City of Surrey
PLANNING & DEVELOPMENT REPORT

Application No.: 7923-0236-00

Planning Report Date: June 24, 2024

To permit construction of a significant temple addition and extension of the parking lot.

DRAWING TITLE
SITE PLAN EAST

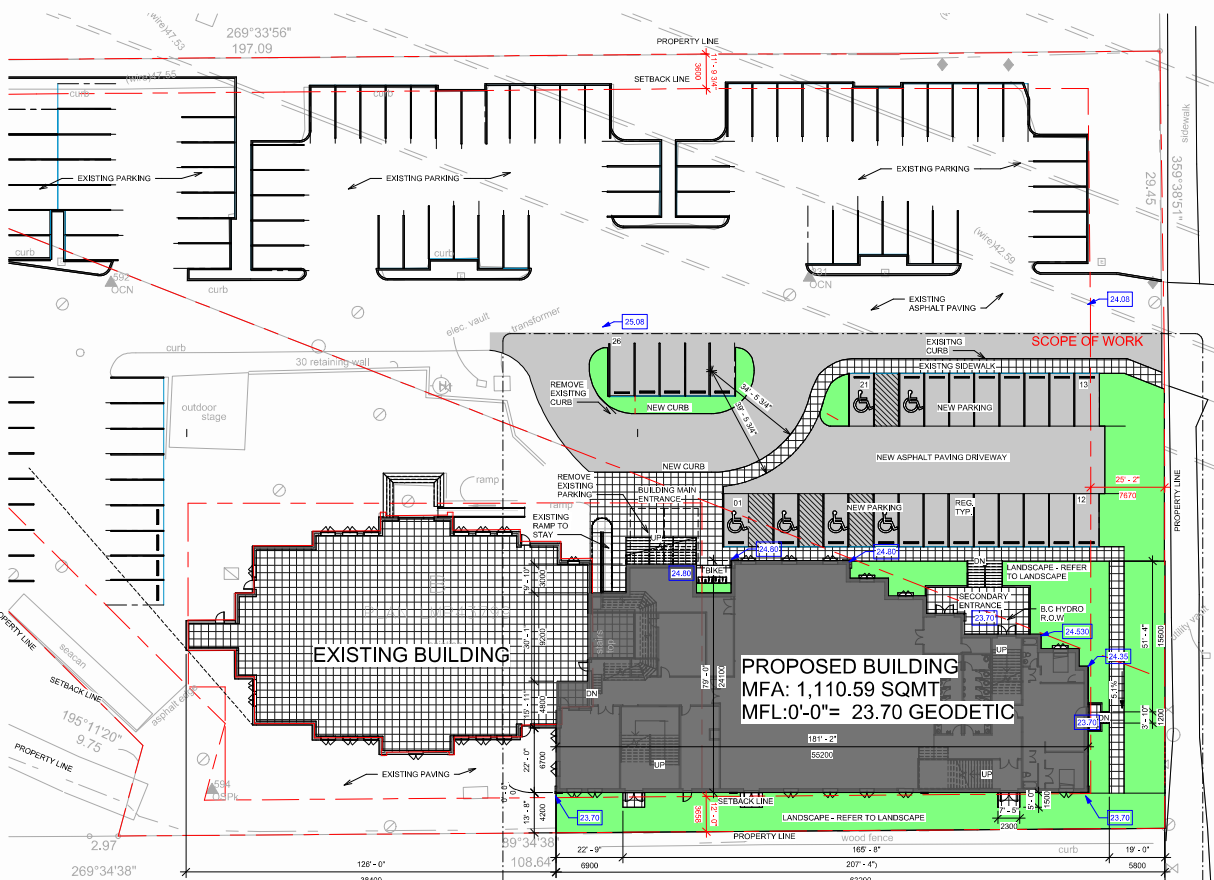
- The proposed addition includes new and relocated rooftop domes, which require a variance for height. The domes are characteristic of mandir buildings and permit more spacious and ornate assembly areas.

- The applicant is requesting the following variances:
 - to increase the maximum building height of the PA-2 Zone allowed from 9 metres to 21.5 metres as measured to the peak of a rooftop dome.
- There is a precedent for taller structures on the subject site and adjacent lots for religious uses on this block.
- The domes comprise significant architectural, heritage, and spiritual components of the proposed building.
- Staff support the requested variances to proceed for consideration.

1. Council approve Development Variance Permit No. 7923-0236-00 (Appendix II) varying the following, to proceed to Public Notification:
 - (a) to increase the maximum building height of the PA-2 Zone allowed from 9 metres to 21.5 metres as measured to the peak of a rooftop dome; and

Figure 1. Proposed development at 8321 140th St, Surrey.

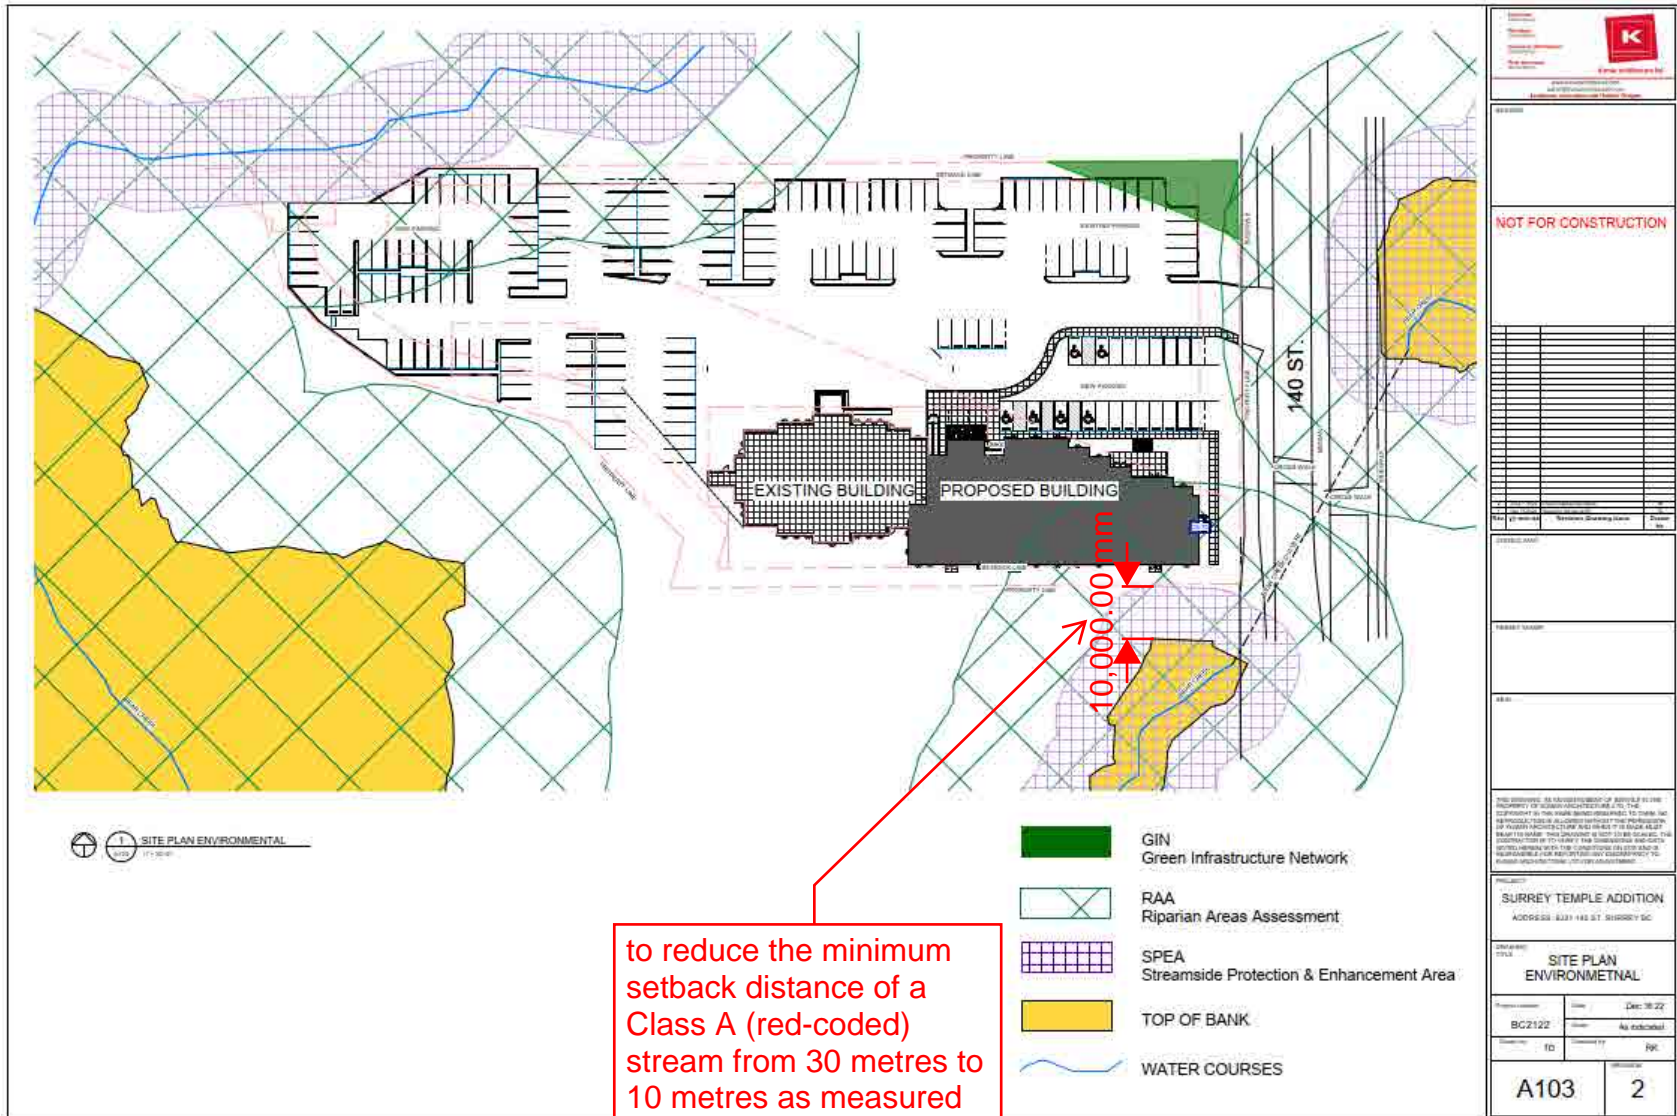
to reduce the minimum setback distance of a Class A (red-coded) stream from 30 metres to 10 metres as measured from top-of-bank

APPENDIX 3 TREE REMOVAL AND RETENTION PLAN

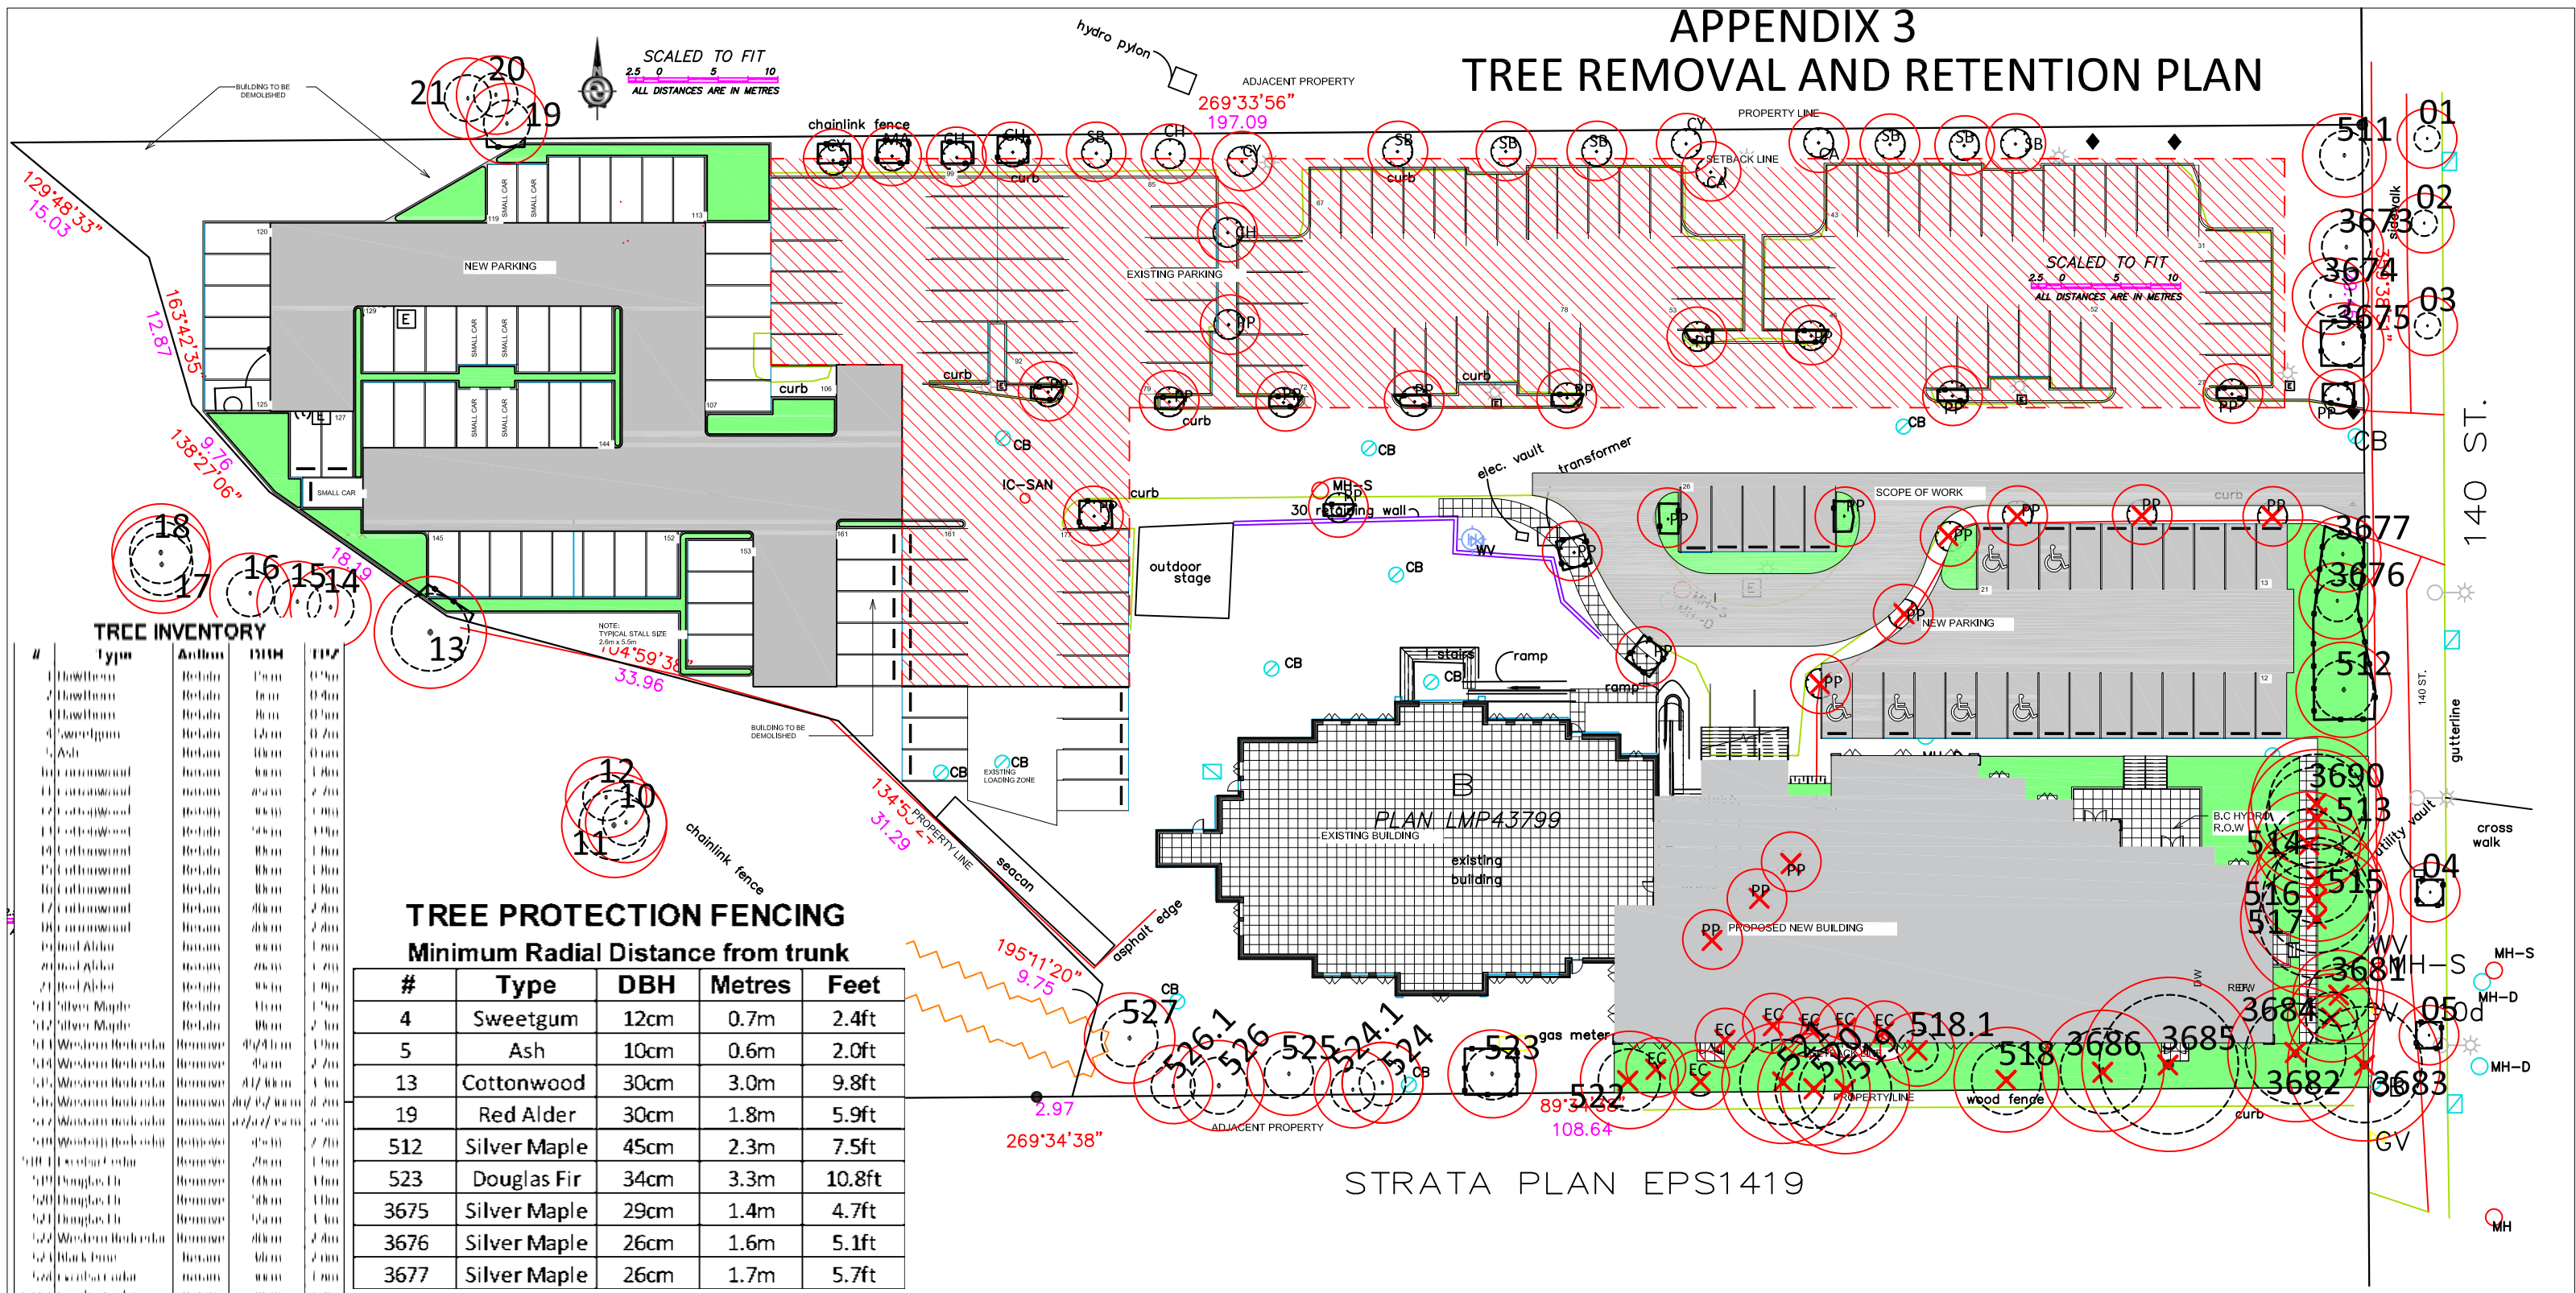
- The Arborist Assessment states that there are a total of 36 mature trees on the site, excluding Alder and Cottonwood trees. Of the 37 existing trees, one (1) is a Cottonwood tree (approximately 2% of the total trees on the site). The applicant proposes to retain 19 trees as part of this development proposal. The proposed tree retention was assessed taking into consideration the location of the building footprints. All trees proposed for removal conflict with the proposed envelope addition on the southeast corner of the lot. No off-site, City, or streamside protection area tree removal is proposed.

- For those trees that cannot be retained, the applicant will be required to plant trees on a 1 to 1 replacement ratio for Alder and Cottonwood trees that are outside the streamside protection area, and a 2 to 1 replacement ratio for all other trees, including Alder and Cottonwood that are within a streamside protection area. This will require a proposed total of 35 replacement trees on the site. A deficit of 35 replacement trees would require an estimated cash-in-lieu payment of \$19,250.00, representing \$550 per tree to the Green City Program, in accordance with the City's Tree Protection By-law.

- (b) submission of a finalized landscaping plan and landscaping cost estimate, satisfying the deficiency in tree replacement on the site, to the specifications and satisfaction of the Planning and Development Department;

- (c) submission of a finalized tree survey and a statement regarding tree preservation to the satisfaction of the City Landscape Architect;
 - (d) submission of a finalized Ecosystem Development Plan and Impact Mitigation Plan to the satisfaction of City staff;
